DOPE FROM HOPE

Vol. 15, No. 1
1 May 1975

We are in the process of making a change in the HERESY Loudspeaker System. After considerable listening tests and a large number of response curves, we have concluded that there is a marginal but realizable and audible improvement that we can make by reversing the polarity of the midrange and tweeter relative to the woofer driver. Obviously, the only physical change in the HERESY will be to the crossover network.

NETWORK TYPE E

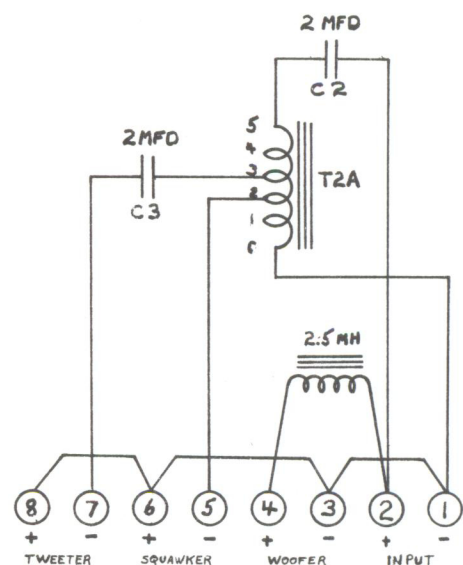
We recommend that you make this change as per the diagram on the merchandise you have in stock. All HERESY Loudspeakers coming out of the factory after Serial Number 14N617 will have this change effected in them and will be designated as a Type "E" Network.
